Project: Provincial Fire and Life Safety Project - Baldur District Hospital and Personal Care Home

ADDENDUM 03

Project:	Provincial Fire Life Safety – Baldur District HC & PCH
Commission Number:	21569.52 SMS Project No.: 24-001-05 / 26-001-12
Date:	Nov 19, 2025
Pages:	2 + 9 attachments + 1 sheet

Project Title
PROVINCIAL FIRE AND LIFE
SAFETY PROJECT
BALDUR DISTRICT PCH & HC

1. E1-111 HC BASEMENT AND MAIN FLOOR PLAN - ELECTRICAL – DEMOLITION
 - a. Added keynote 2 to keynote list. Refer to keynote bubbles on drawing for further information.

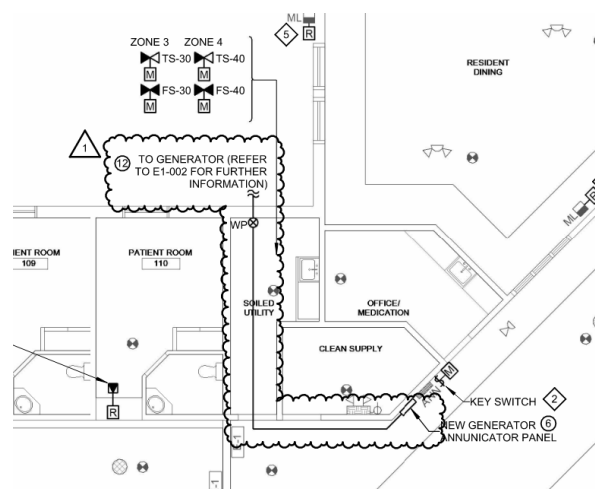
Question: There is no demo keynote 2 on drawing E1-111, is this an error?

Answer: Yes, see below electrical drawing revisions.

3. E1-302 SINGLE LINE DIAGRAM – NEW CONSTRUCTION

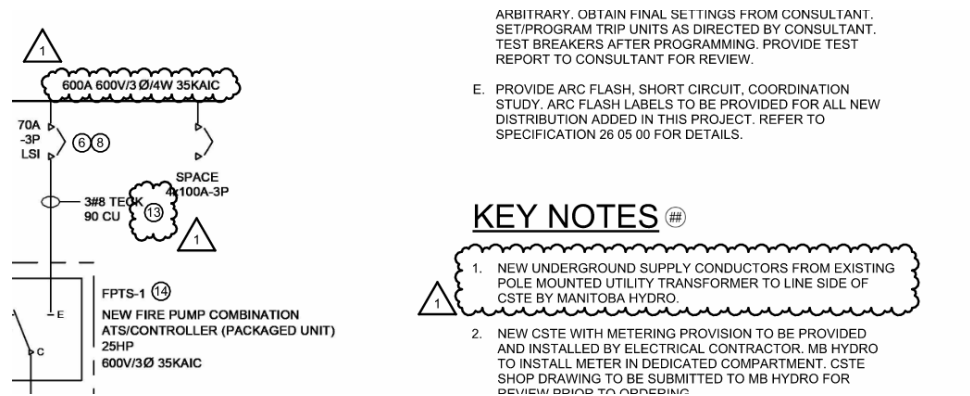
Question: The voltage for EMD-1 appears incorrect, is it supposed to be 600V instead of 120/208V?

- a. Revised keynote 1.
- b. Added keynote bubble 13 beside FPTTS-1 emergency feeder.
- c. Revised EMD-1 voltage from 120/208V to 600V.

Answer: This is correct. See below electrical drawing revisions.

4. E1-303 ELECTRICAL DETAILS

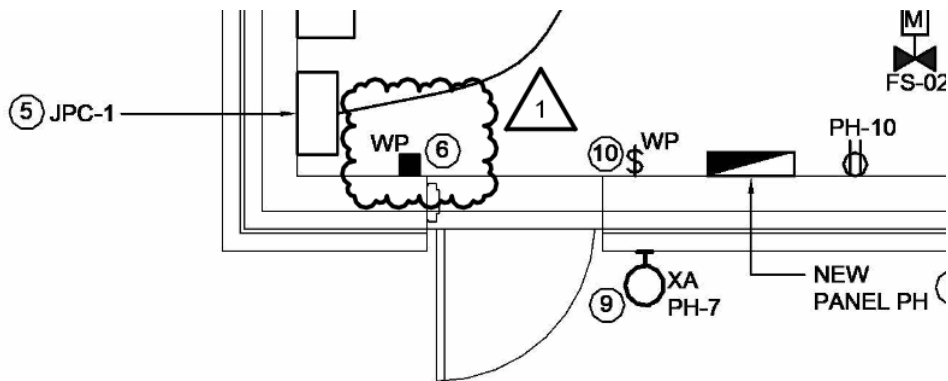
- a. Refer to detail 5. Added keynote 6 bubble beside pull station.
- b. Refer to detail 5. Added weatherproof rating for pull station.

S1-401

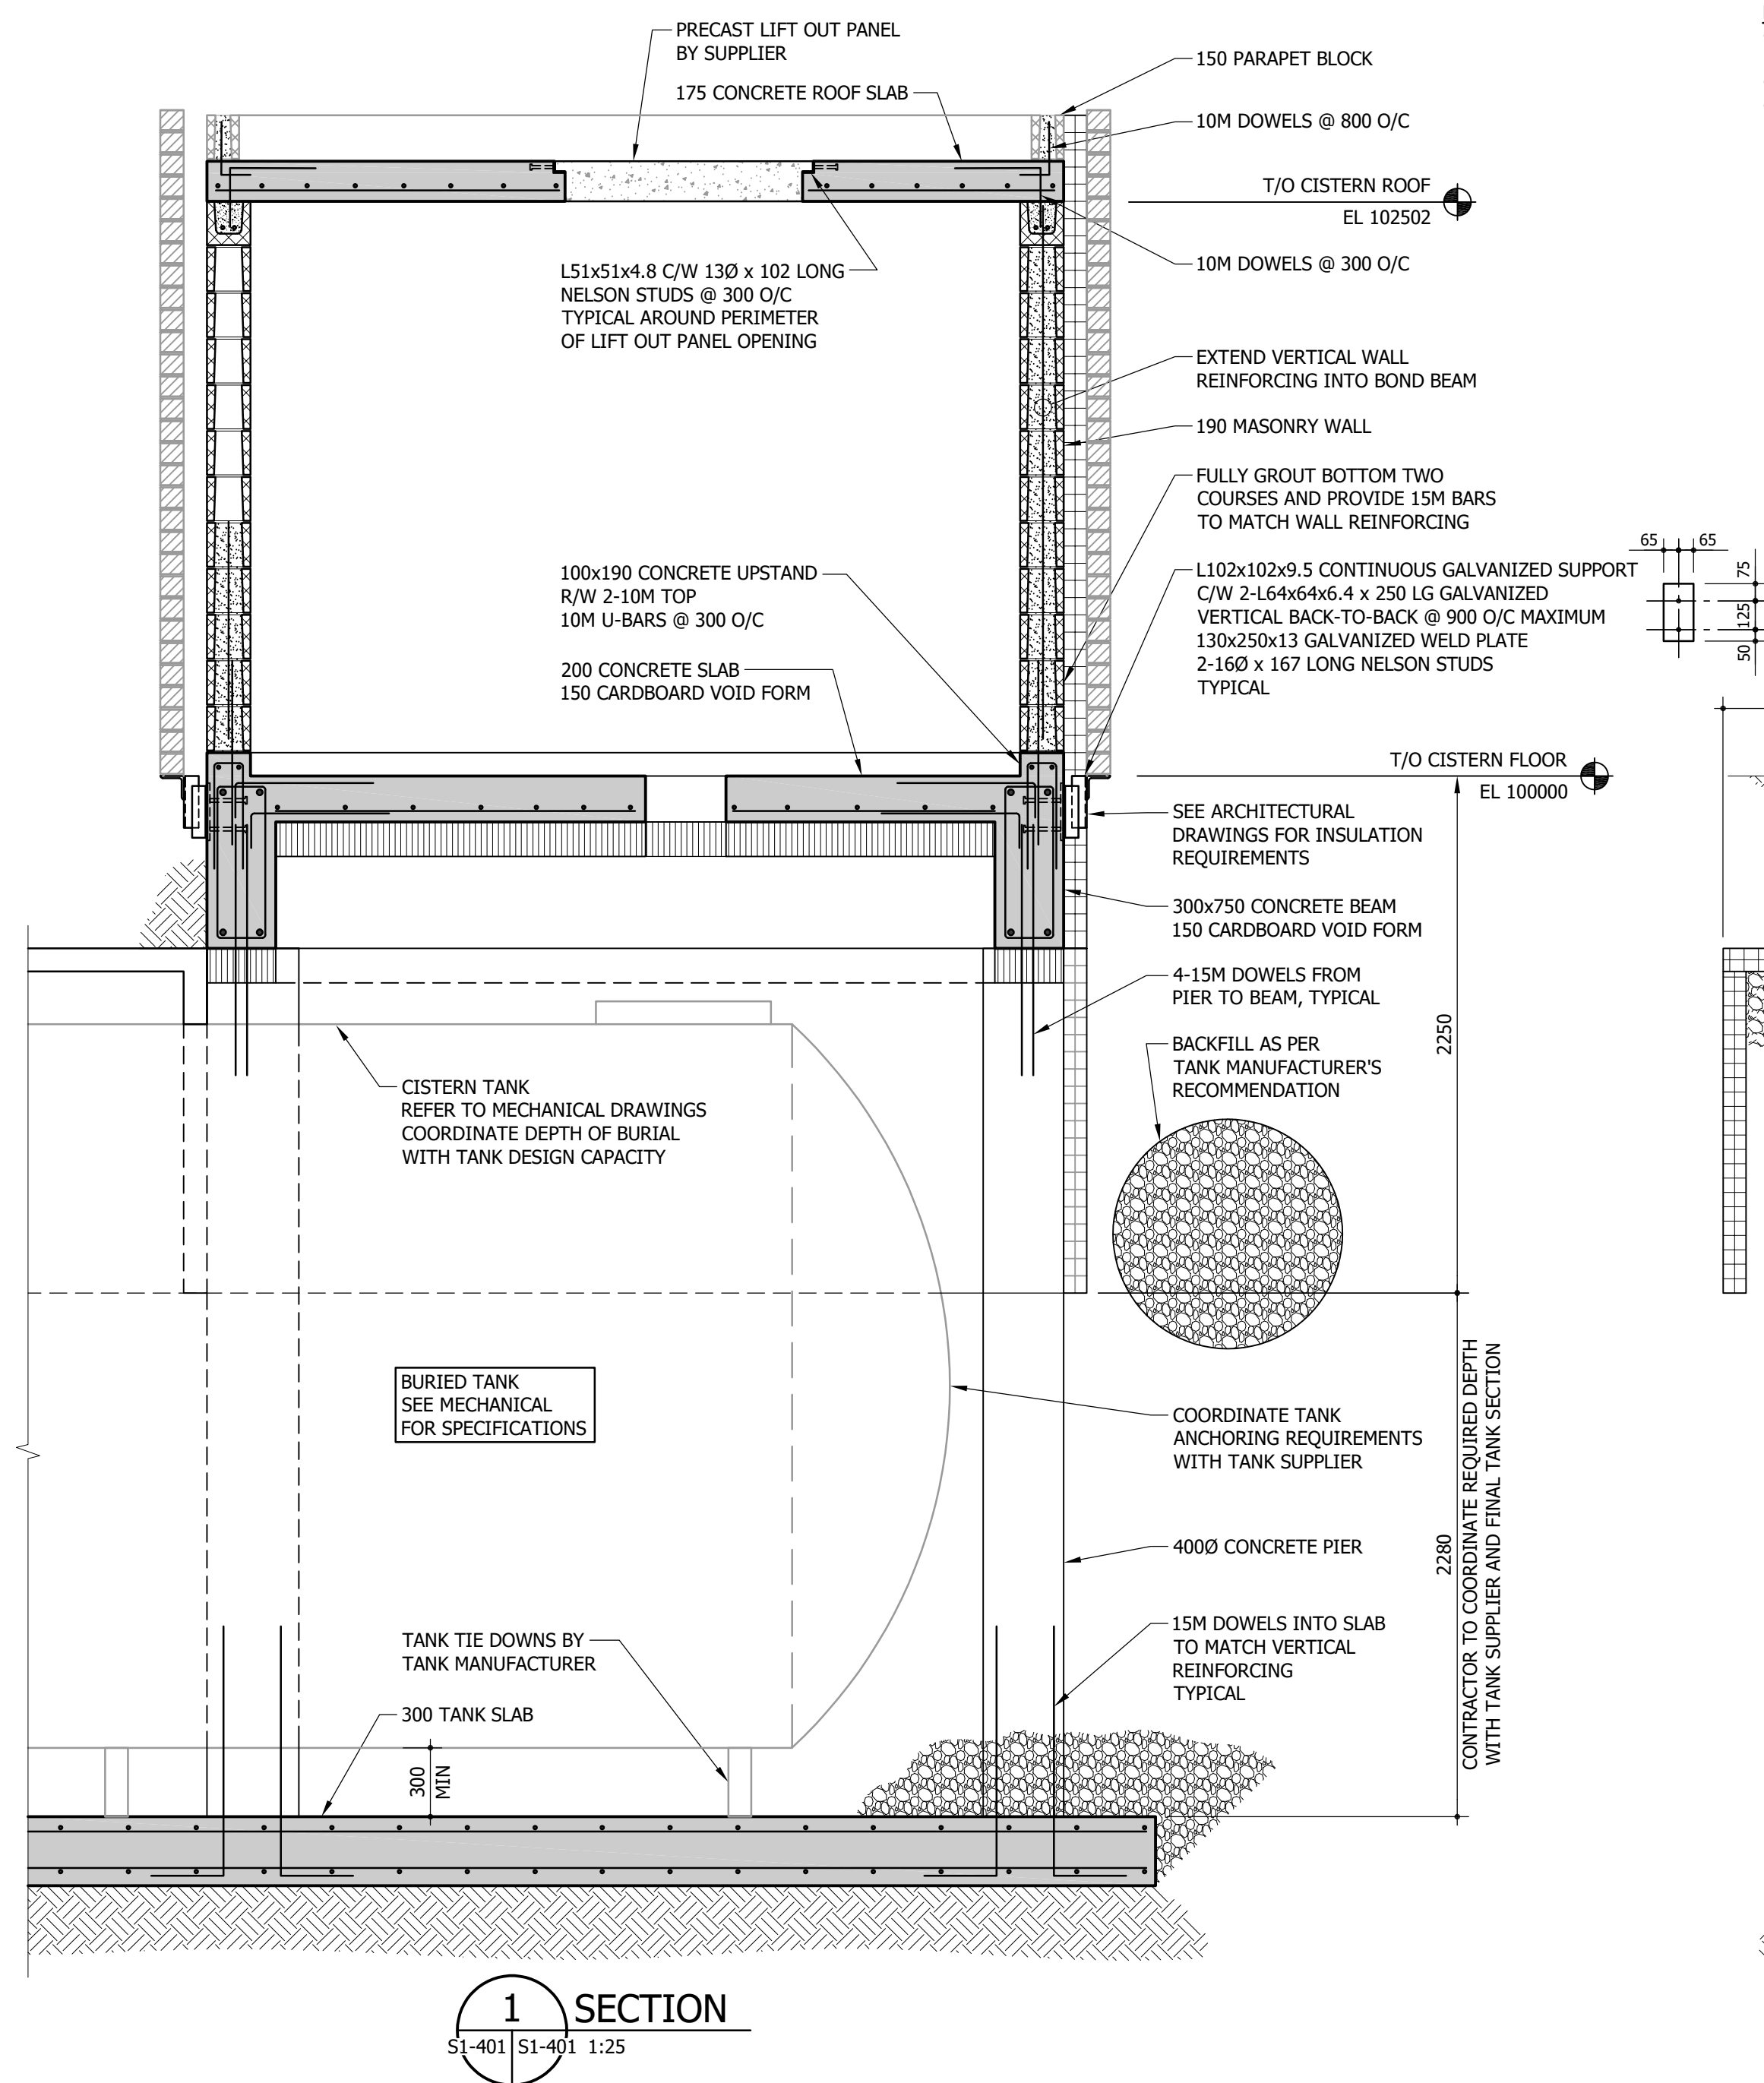
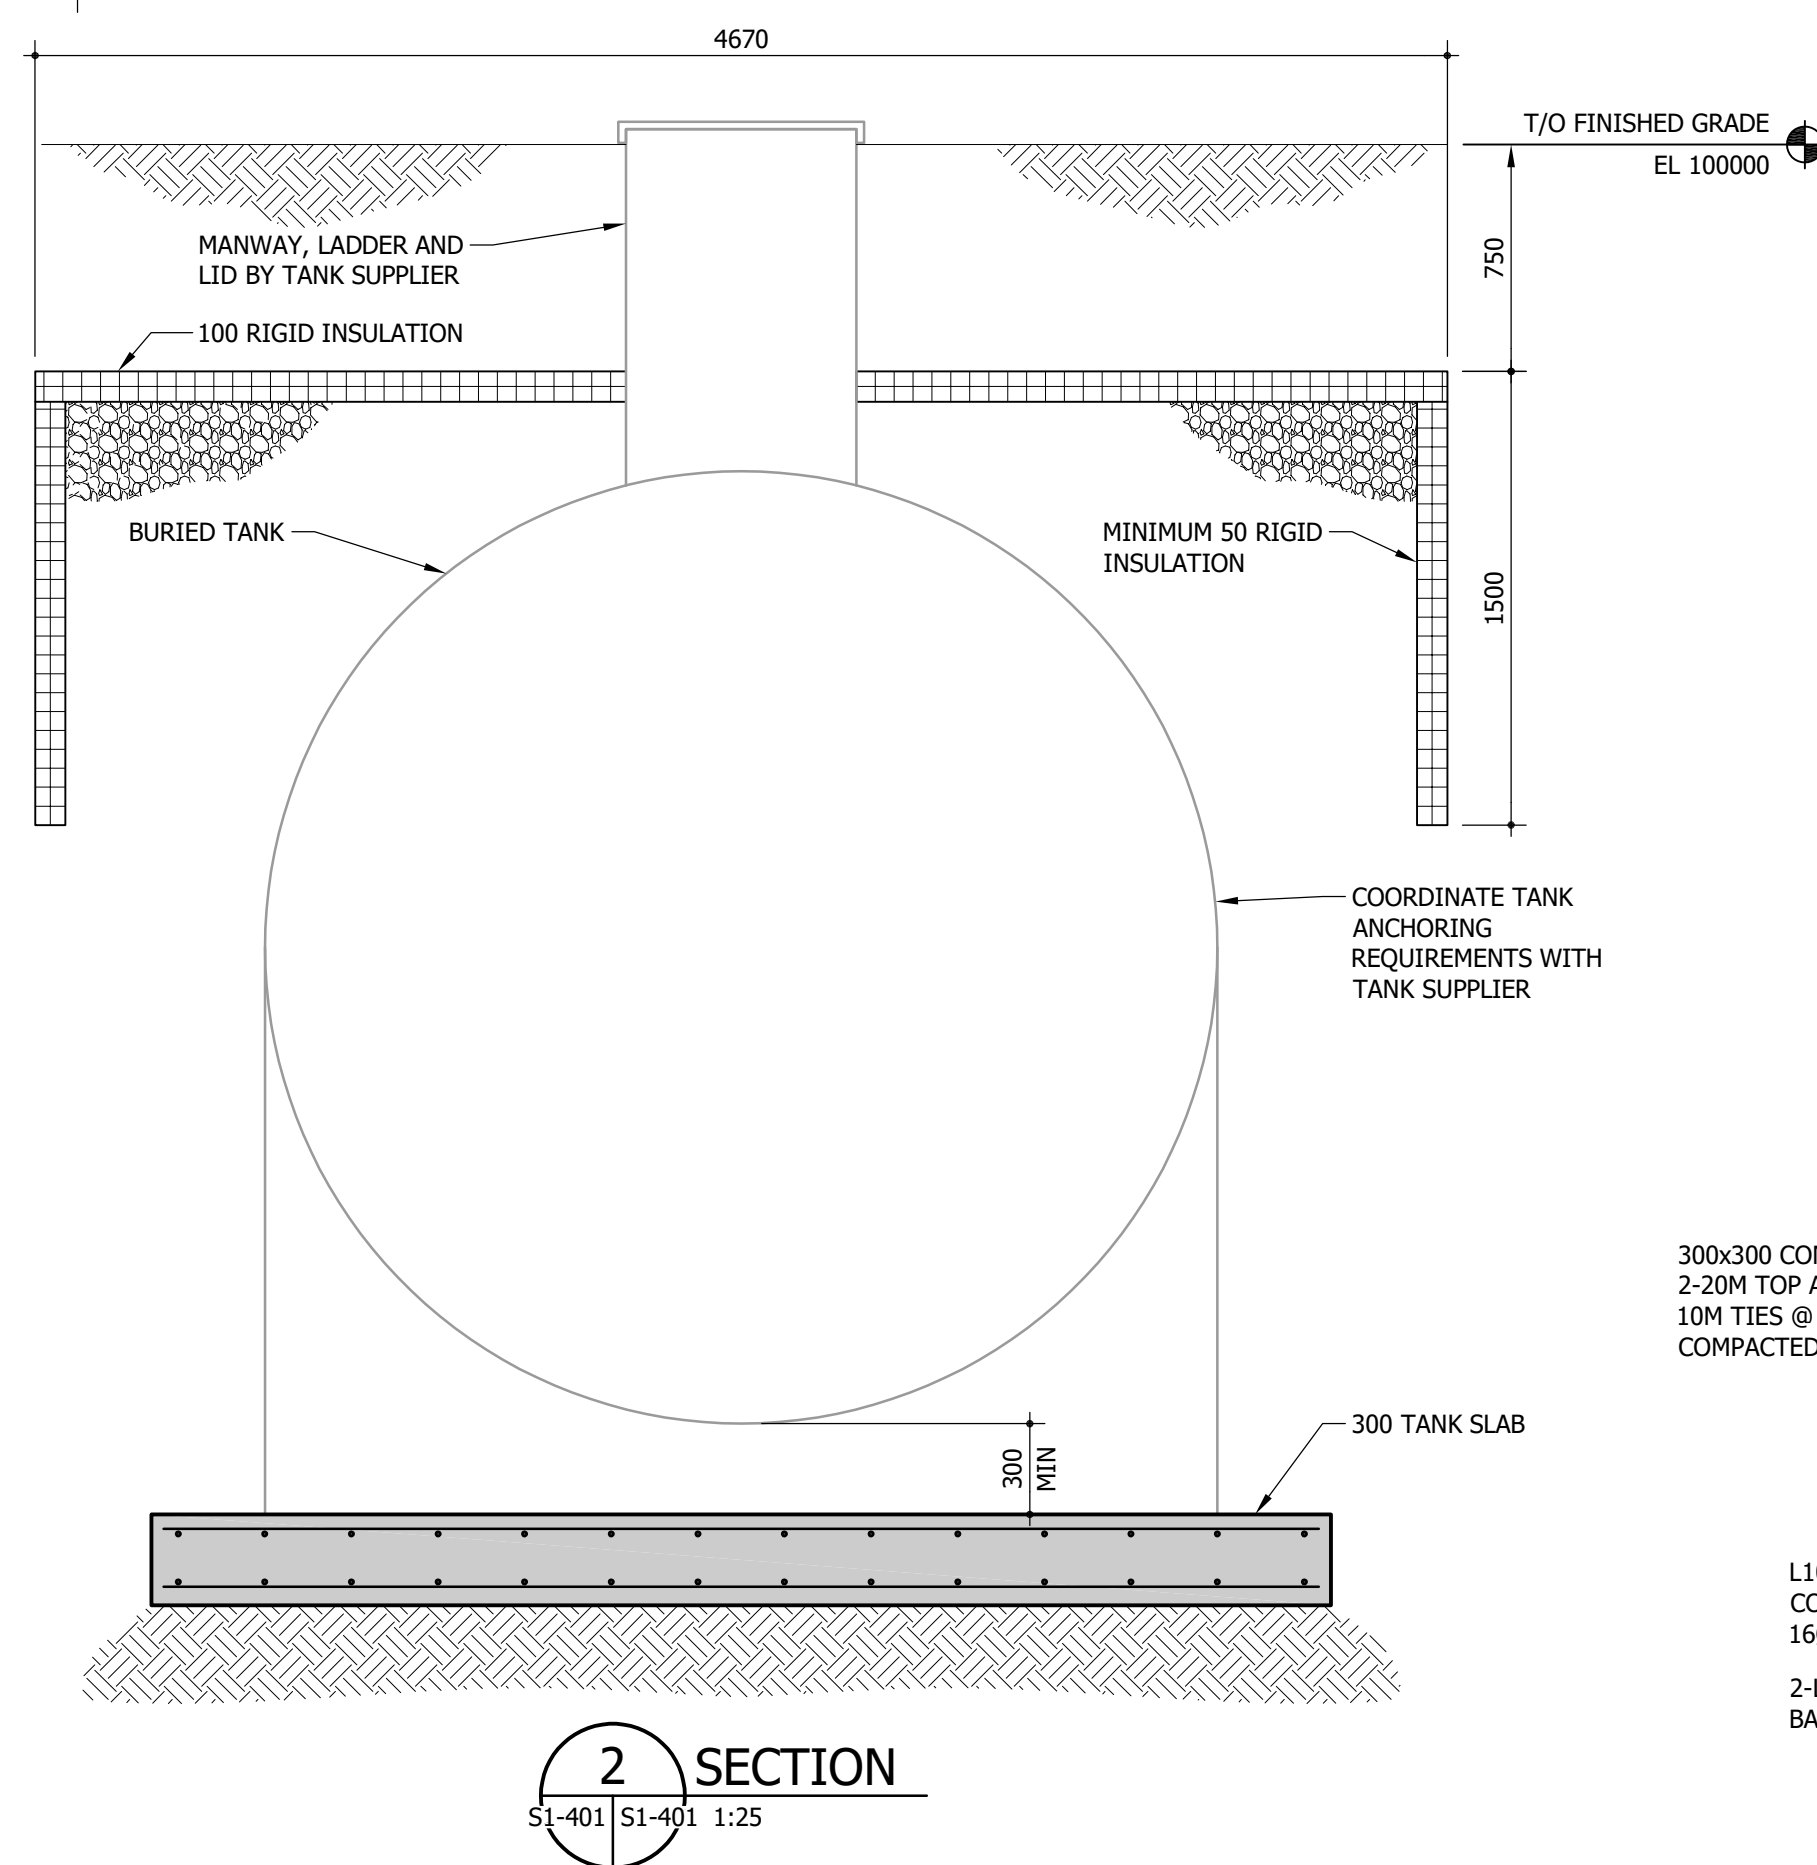
Question: On drawing S1-401: detail section 1, can the beams be poured first and then the floor slab with the curb second?

Refer to S1-401 (attached). Decreased size of Fire Pump House on S1-401 to match Architectural and Mechanical drawings.

Answer: Yes, the beams and slabs can be poured separately, minimum 40mm deep construction joint key is required as per the structural general notes.
